**ADDENDUM NO. 1 TO ALL BIDDERS:**

Invitation to Bid: **ITB No. SOL1254**

Description: **Public Works Service Center and Fire Stations 4 & 6 Fueling Improvements**

**ATTACHMENT A TO**  
**ITB NO. SOL1254**  
**PUBLIC WORKS SERVICE CENTER AND FIRE STATIONS 4 & 6 FUELING IMPROVEMENTS**  
**REVISED DRAWINGS**

SHEET NUMBER:  
**E502-PW**

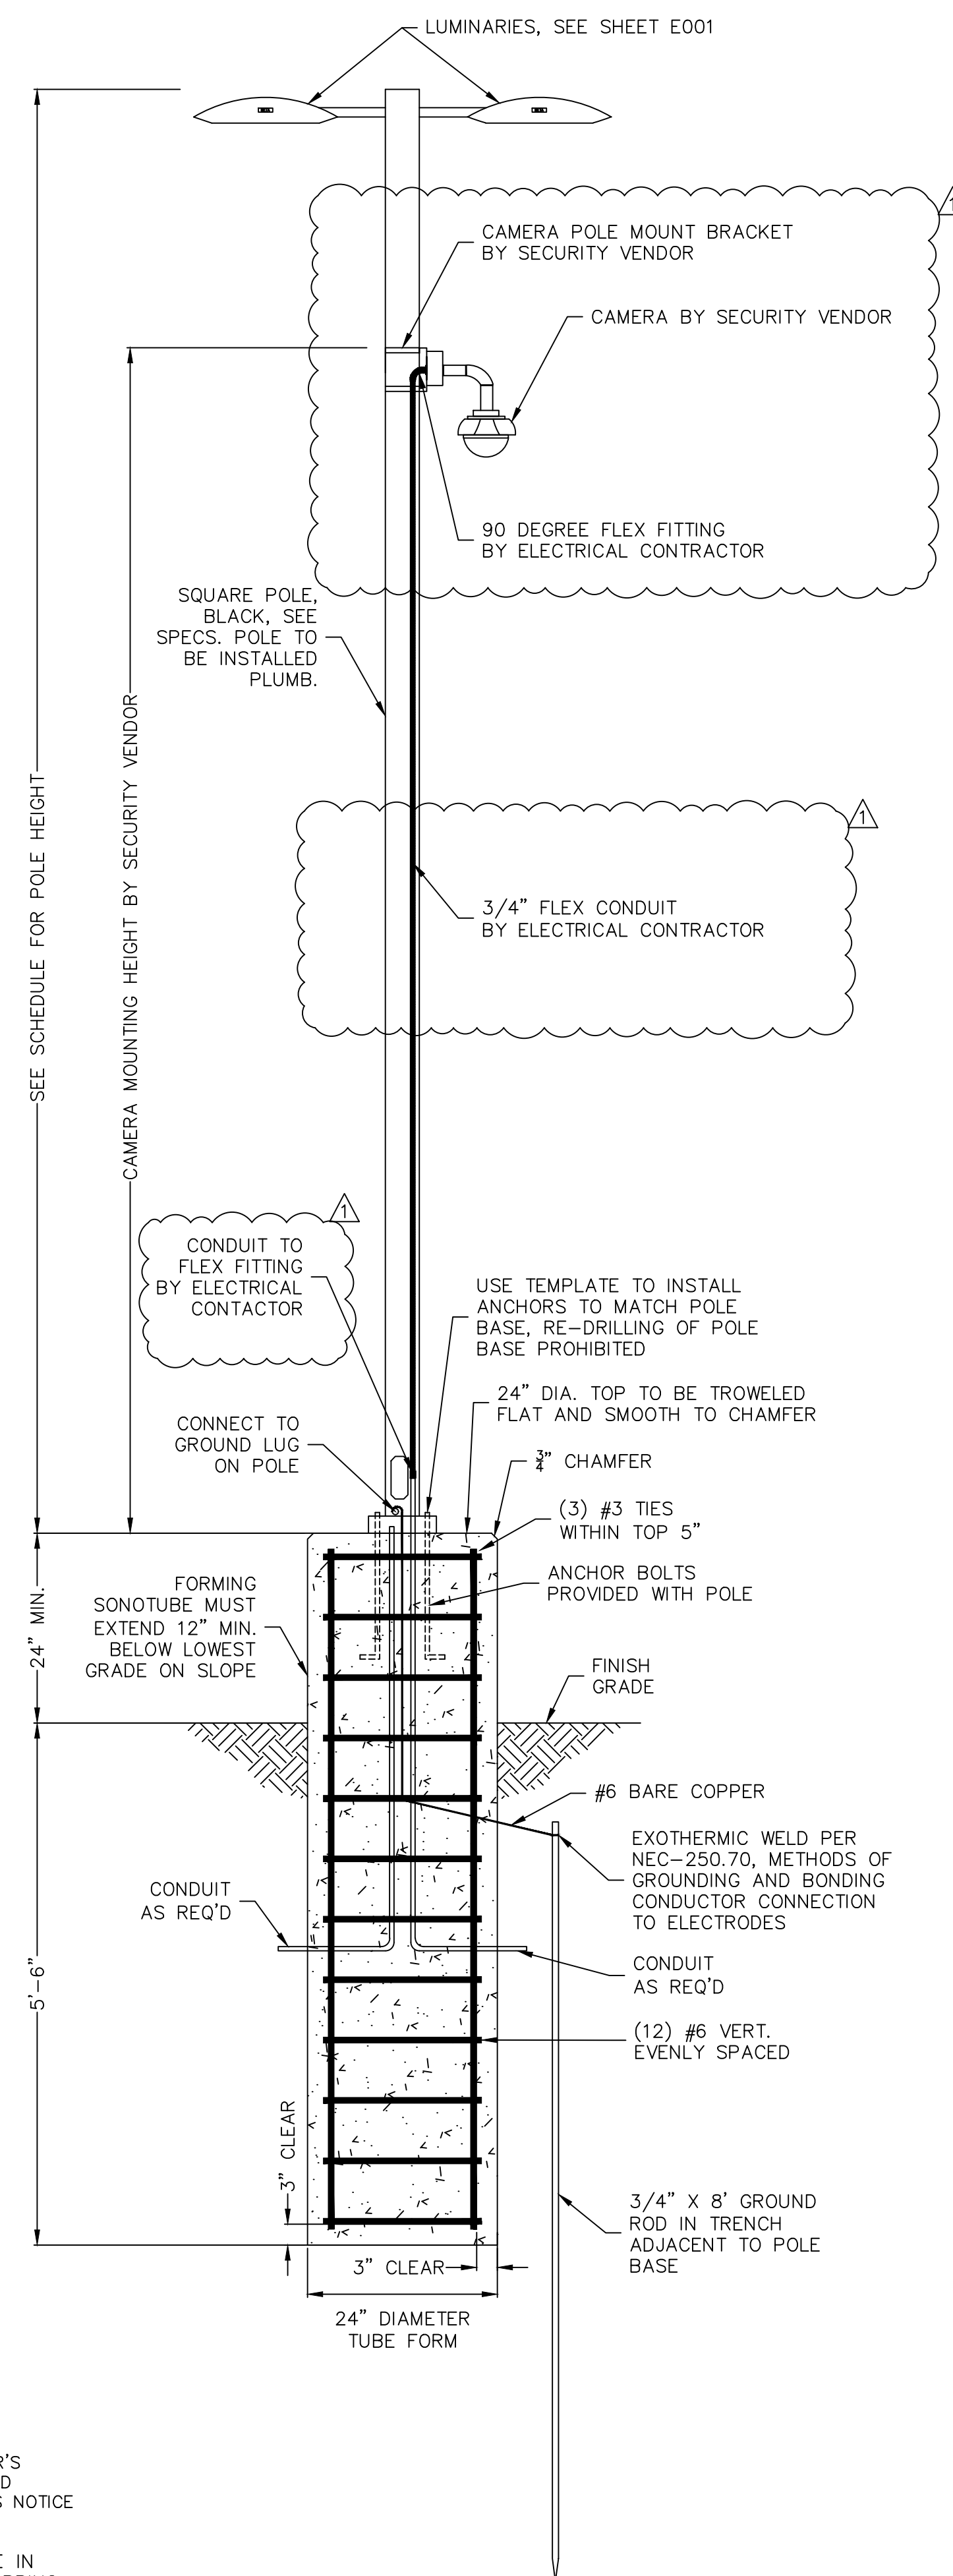
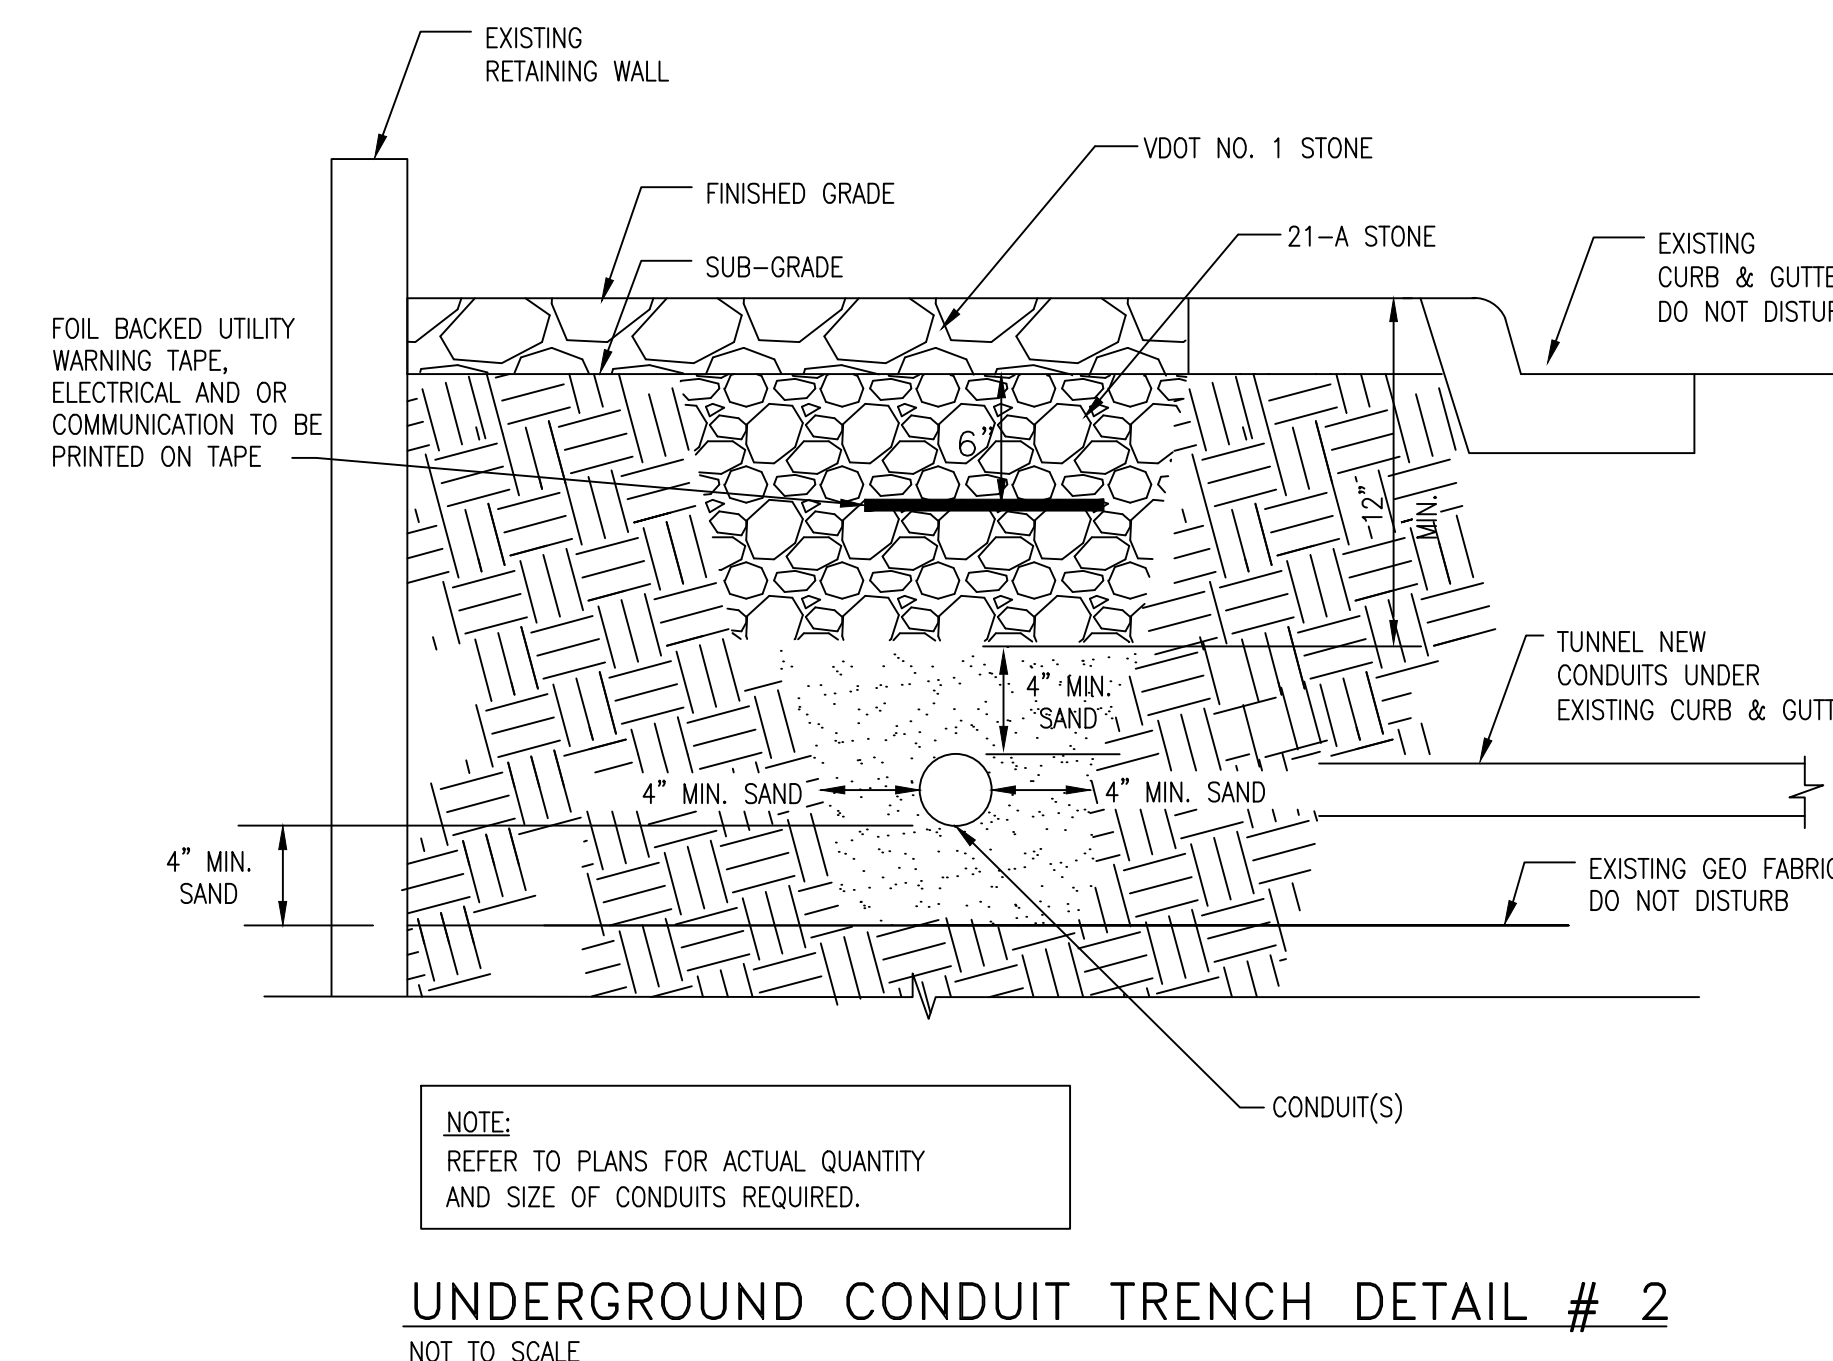
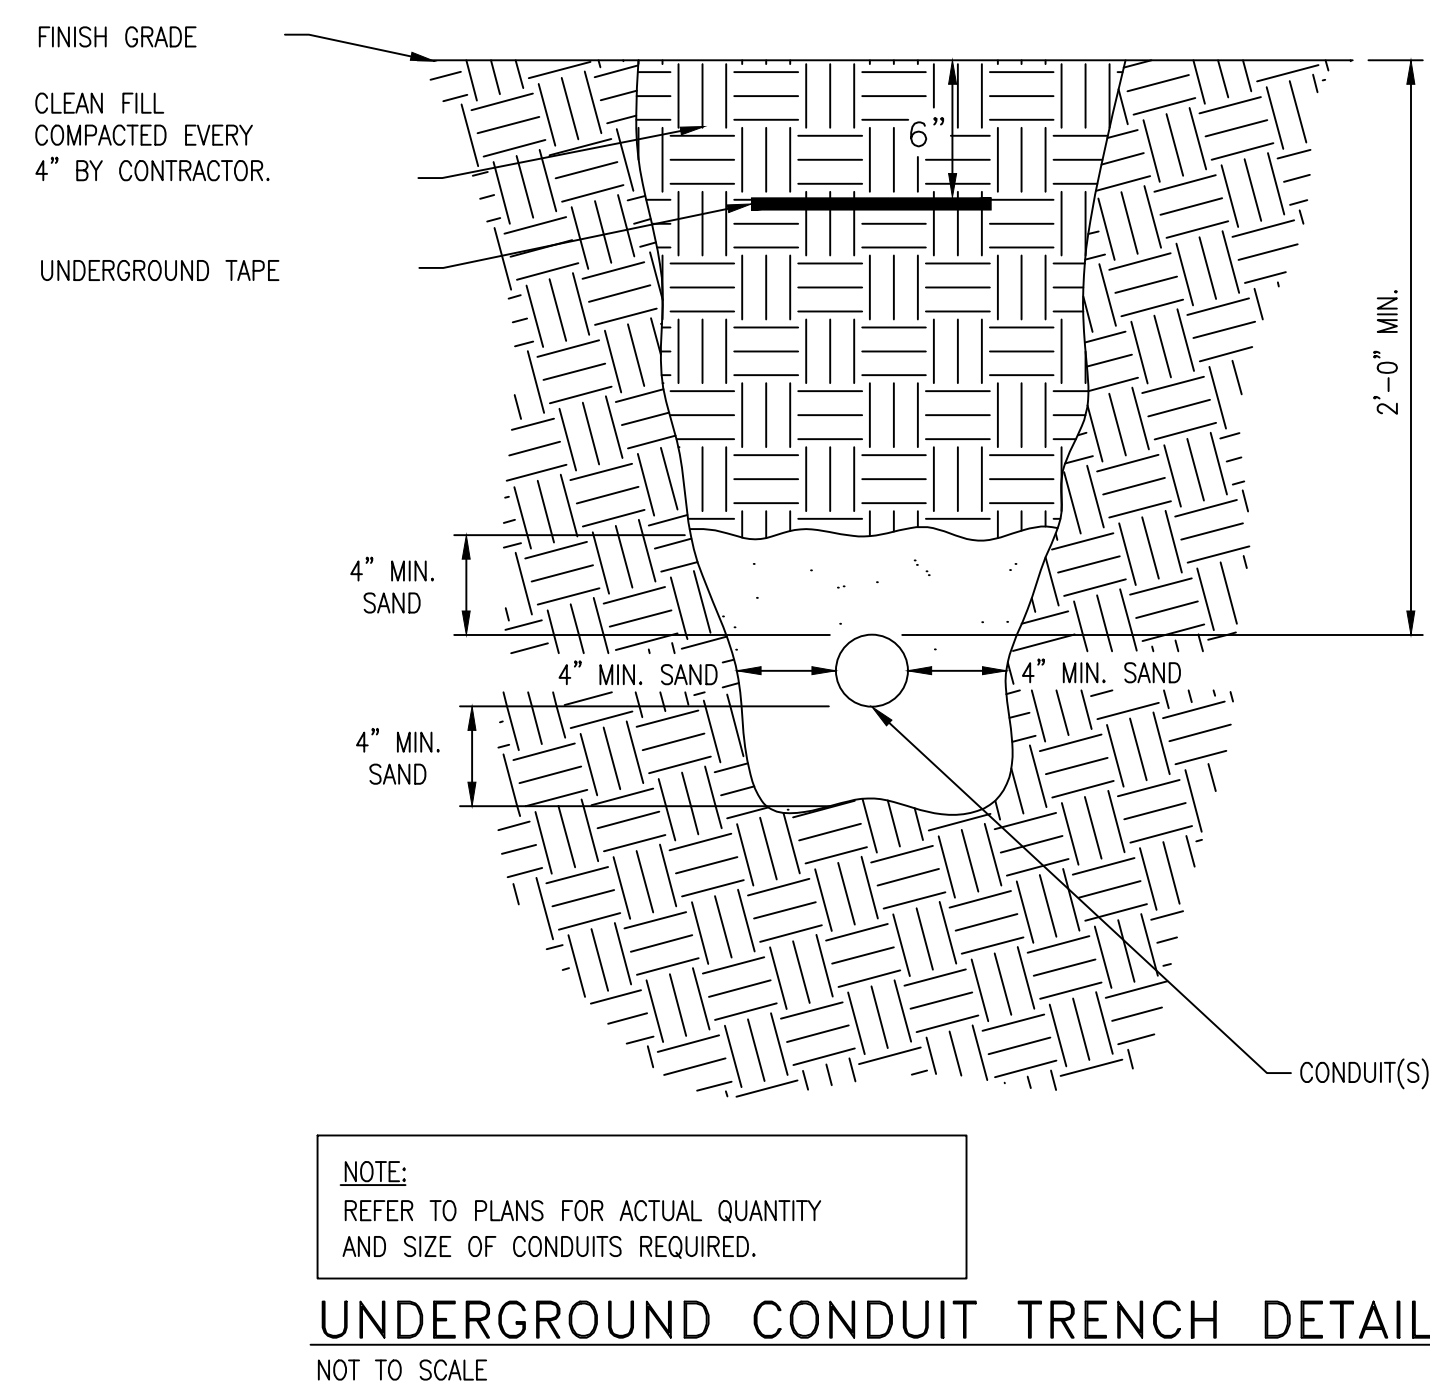
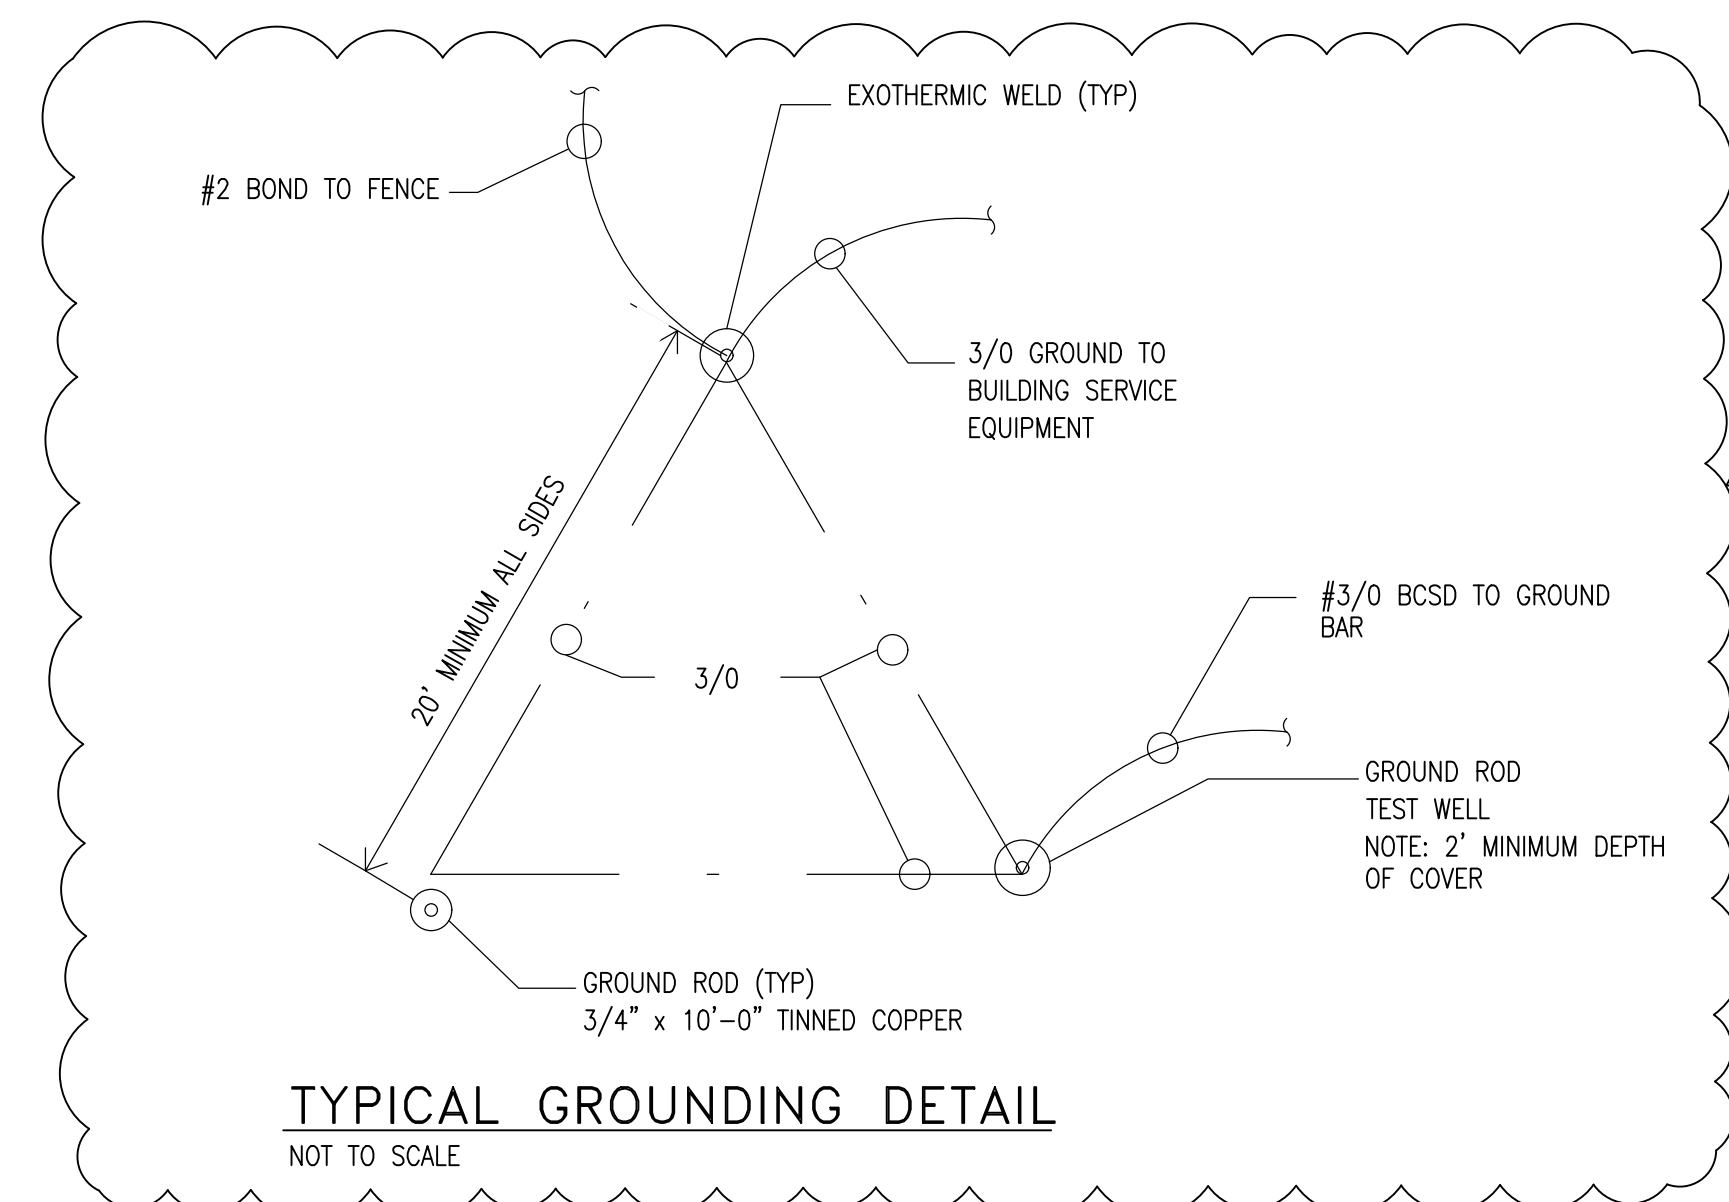
FS4	DETAILS	
E501-FS6	ELECTRICAL – DETAILS	Typical Grounding Detail added to the sheet.
E101-PW	ELECTRICAL – SITE PLAN	<ul style="list-style-type: none"> <li>• Sheet notes added/modified.</li> <li>• Conduits added for keyless entry at vehicular gate and pedestrian gate. Keyless entry equipment locations shown.</li> <li>• Conduits to vehicular gate operator were clarified.</li> <li>• Conduits to propane shown.</li> <li>• Conduit duct bank configurations modified (several places).</li> <li>• Conduit to main building relocated to be in the grass.</li> <li>• Conduit through main building to Telecom Room clarified.</li> </ul>
E102-PW	ELECTRICAL – SITE PLAN	<ul style="list-style-type: none"> <li>• Sheet notes added/modified</li> <li>• Conduit duct bank configurations modified (several places).</li> <li>• Two (2) camera locations added in lower lot.</li> </ul>
E502-PW	ELECTRICAL – DETAILS	<ul style="list-style-type: none"> <li>• Typical Grounding Detail added to the sheet.</li> <li>• Light pole base details modified to show security camera requirements.</li> </ul>
